RE: Request For Permit Modification
Capital Improvements Project
Stoney Mountain Road Landfill
Henderson County, North Carolina
Permit # 45-04-T

On behalf of Henderson County, McGill Associates is pleased to make this submittal for a minor modification/update to the existing Permit to Construct for the proposed Capital Improvements Project at the Stoney Mountain Road Landfill Facility, Permit #45-04-T, in Henderson County, North Carolina. As we discussed the other week, the County would like to include some upgrades/modifications to Transfer Station No. 2 as well as modify the discharge piping associated with the entrance trench drain system at Transfer Station No. 1. For reference, Transfer Station No. 2 is the newer/larger of the two transfer stations.

STONEY MOUNTAIN ROAD LANDFILL
CAPITAL IMPROVEMENTS PROJECT
CONSTRUCTION PLANS
HENDERSON COUNTY
HENDERSON COUNTY, NORTH CAROLINA

SHEET
C-102

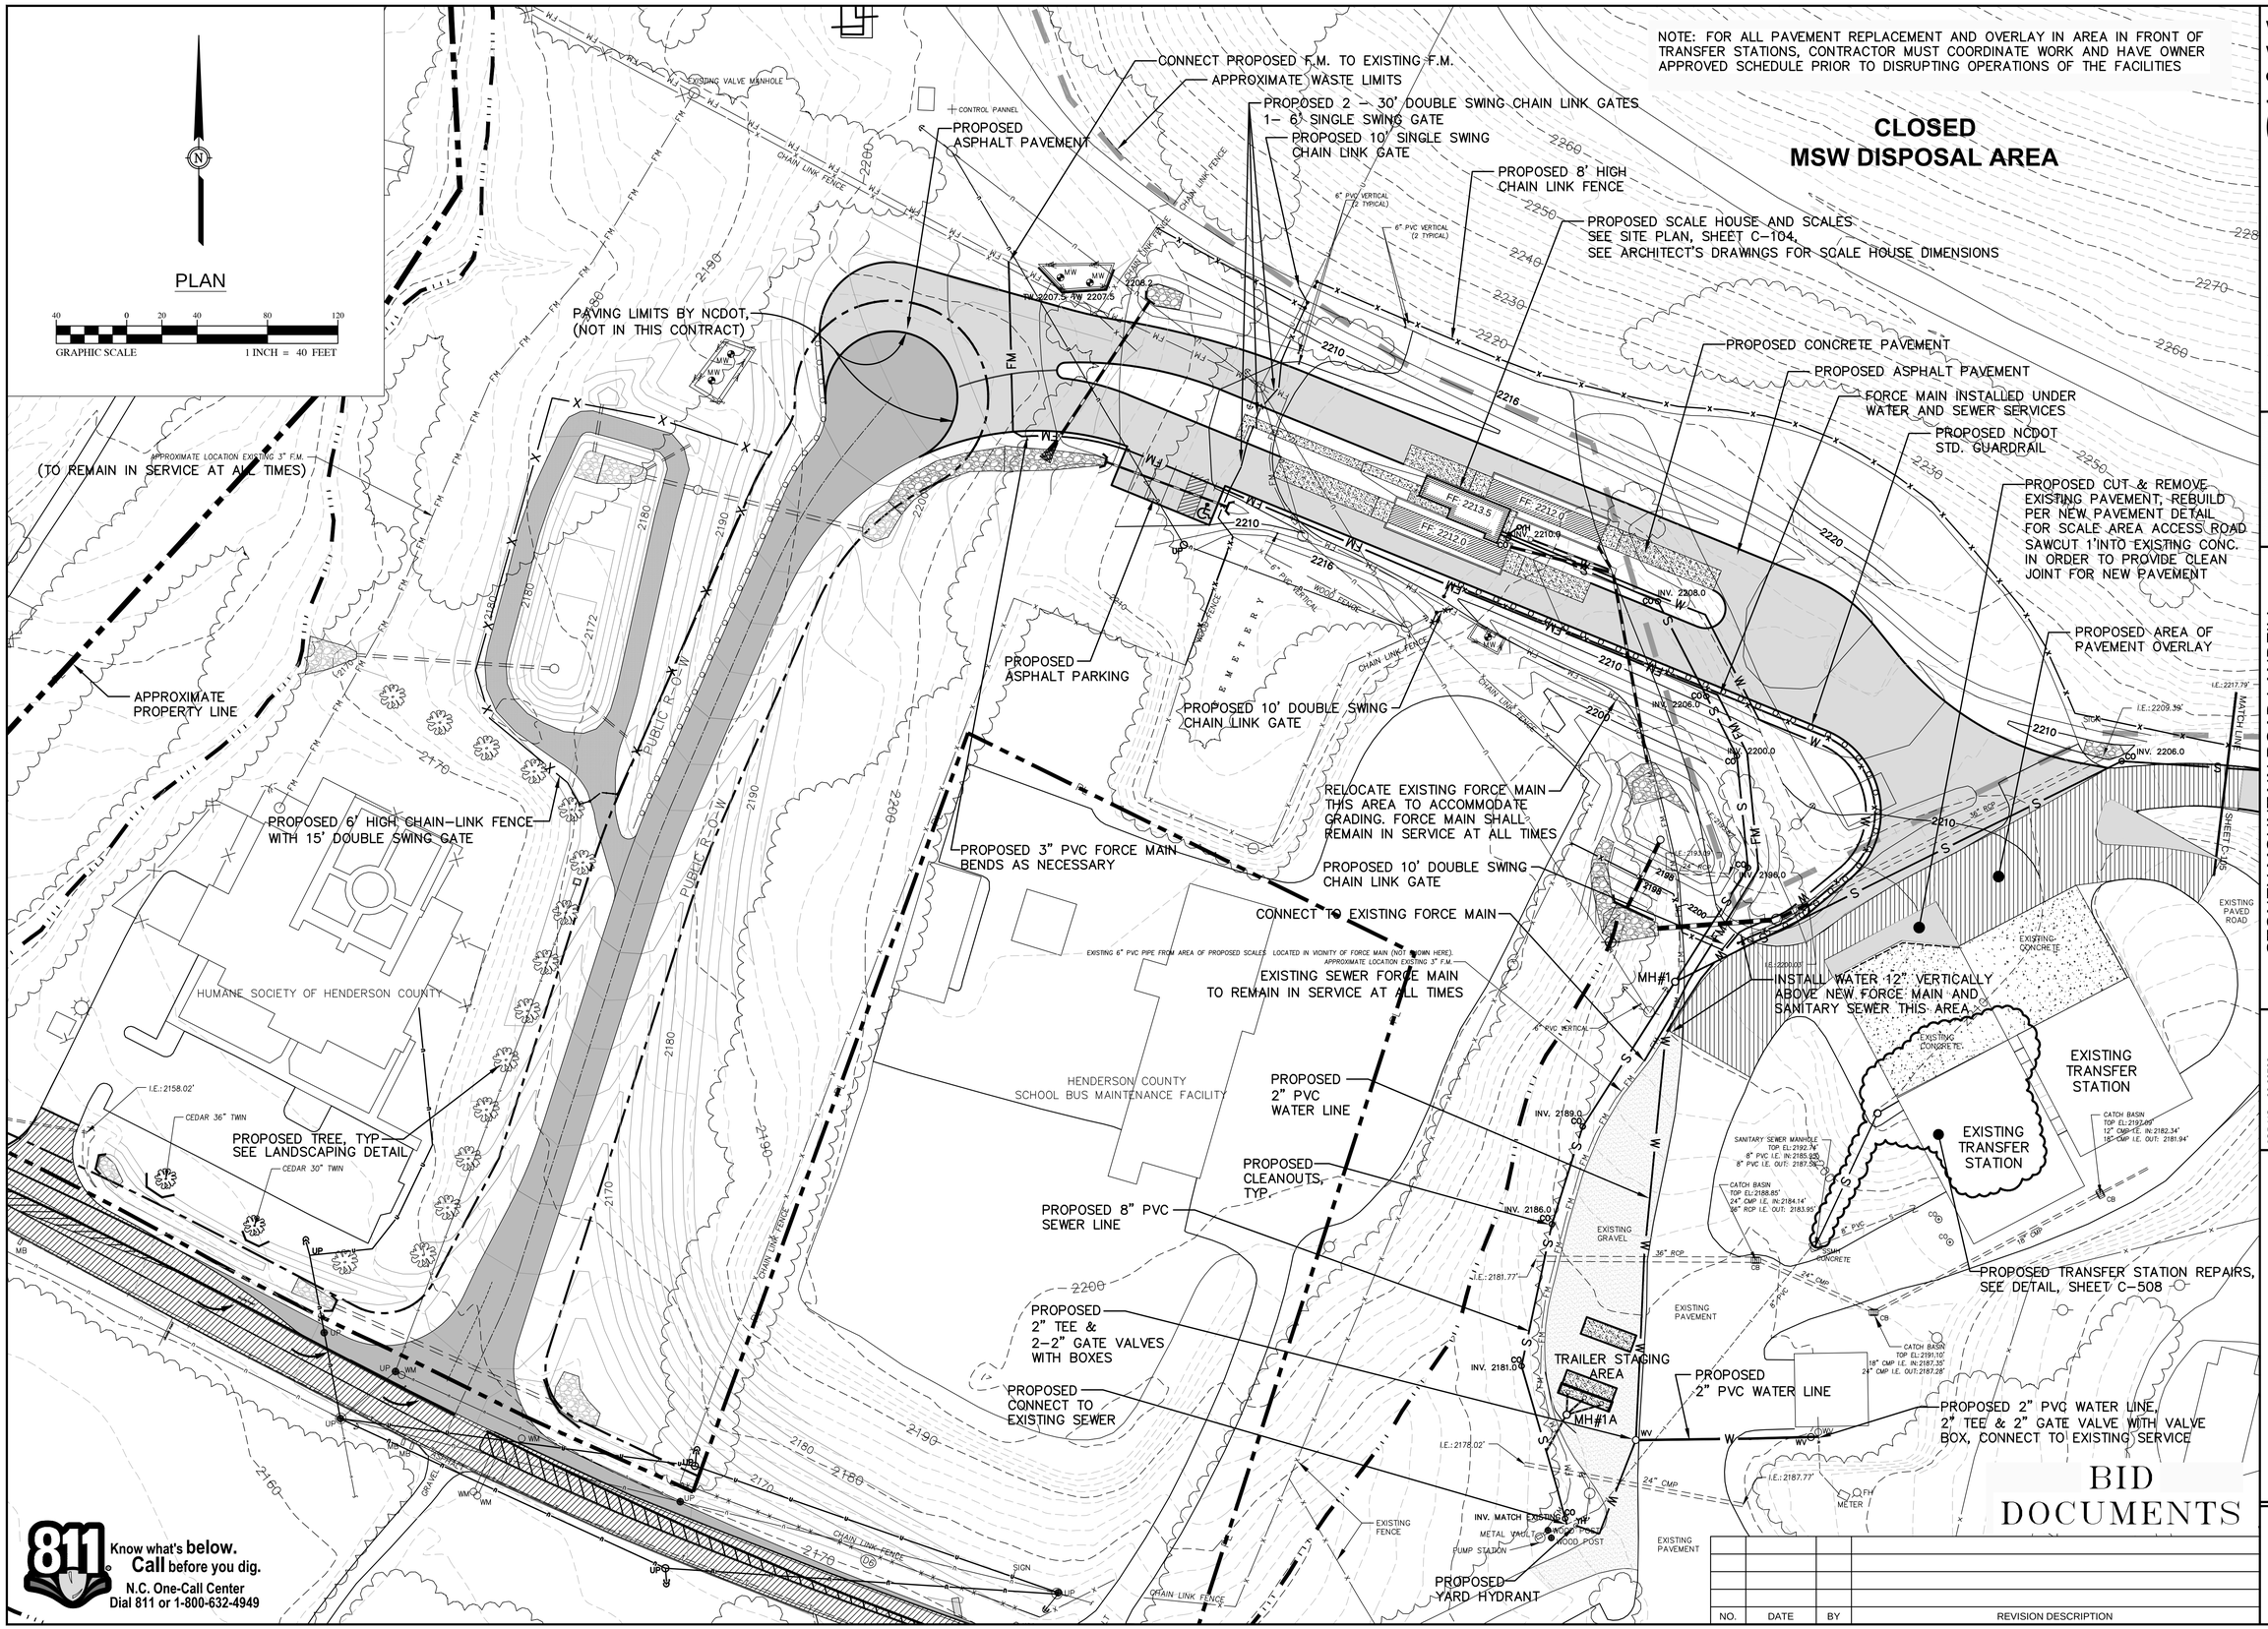
The proposed plan is to modify the discharge piping from the existing trench drain system at the entrance to Transfer Station No. 1. The plan is to increase the size of the discharge line and provide a more direct route to a proposed manhole to be located to the west of Transfer Station No. 2. The existing drain lines will be removed and/or capped/plugged as a part of this proposed construction. The proposed plan also includes removing and replacing the entire entrance trench drain system and piping associated with Transfer Station No. 2. This is needed as the grating system associated with the trench drain is beginning to fail as is the liquid collection and discharge piping system. The proposed drain line from the new trench drain will also discharge directly to the proposed manhole to be located to the west of Transfer Station No. 2. As with Transfer Station No. 1, the existing drain lines will be removed and/or capped/plugged as a part of this construction. From the proposed manhole, located immediately to the west of Transfer Station No. 2, a larger direct discharge line will be installed to the existing sanitary sewer manhole located further west and down gradient of Transfer Station No.

2. The proposed upgrades should improve the County's ability to collect and manage the liquid waste collected in the trench drain systems located at the entrances to the two transfer stations.

To facilitate your review of the proposed improvements, I have enclosed a copy of Sheet C-102, Scale Area Site Plan, which shows the location of the proposed new manhole and the associated discharge piping. The proposed improvements/upgrades to the piping systems and the new trench drain system for Transfer Station No. 2 is shown on the enclosed Sheet C-508, Miscellaneous Details. Sheet C-508 also includes the details for the tipping floor replacement associated with Transfer Station No. 2. I have enclosed a computer disk with the aforementioned drawings in electronic format for your use.

SHEET
C-508

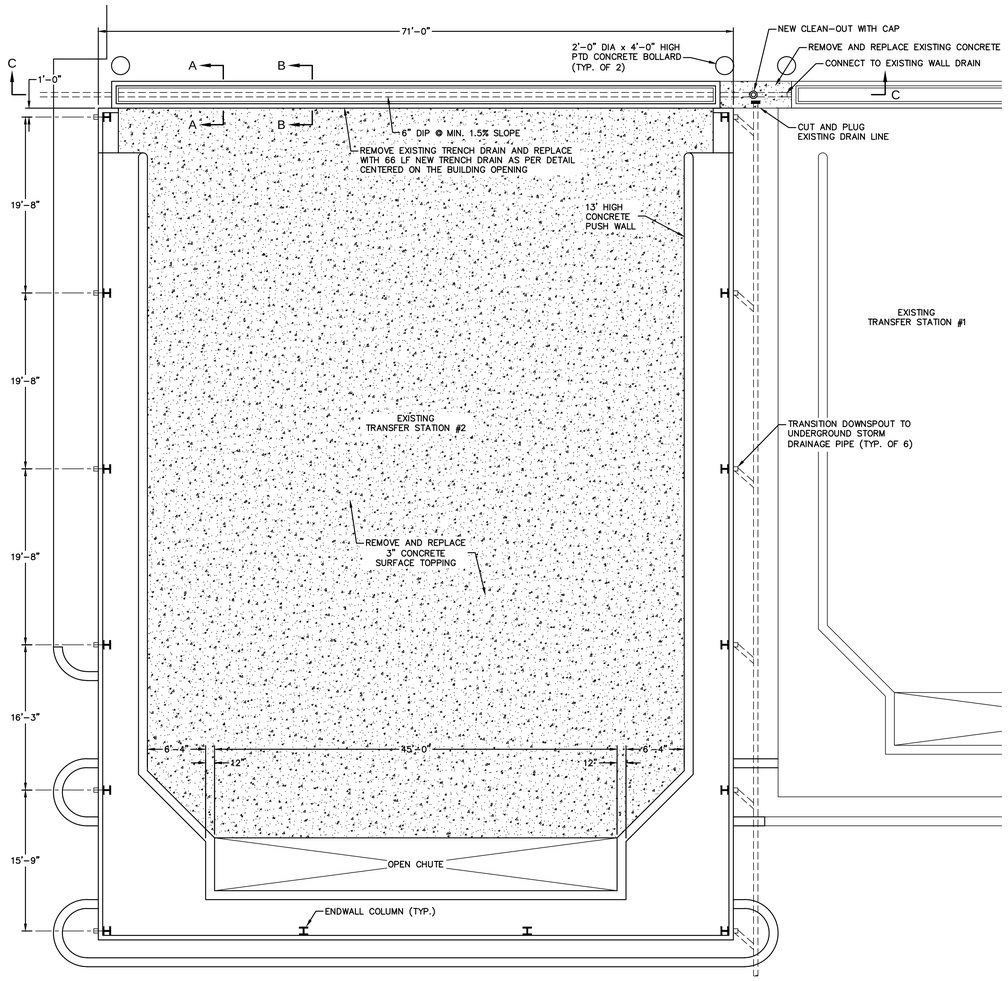
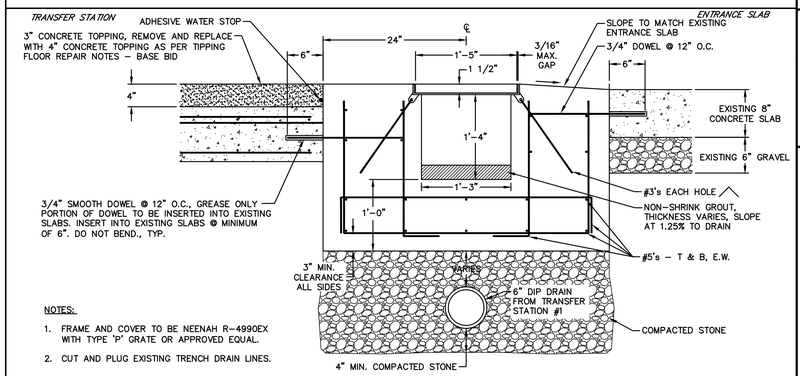
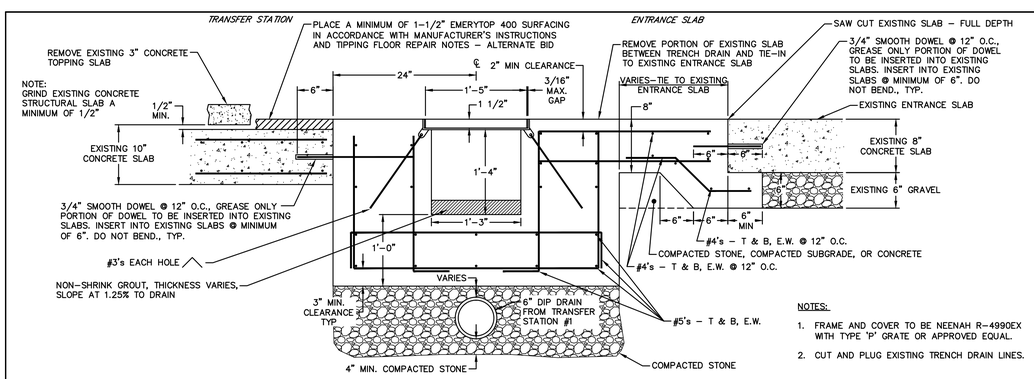
In addition to the proposed upgrades to the entrance trench drain systems, the County has included as a part of the Capital Improvements Project, the removal and replacement of the tipping floor surface in Transfer Station No. 2.

PROPOSED TRENCH DRAIN SECTION B-B - BASE BID 2

PROPOSED TRENCH DRAIN SECTION B-B - ALTERNATE BID ITEM 2
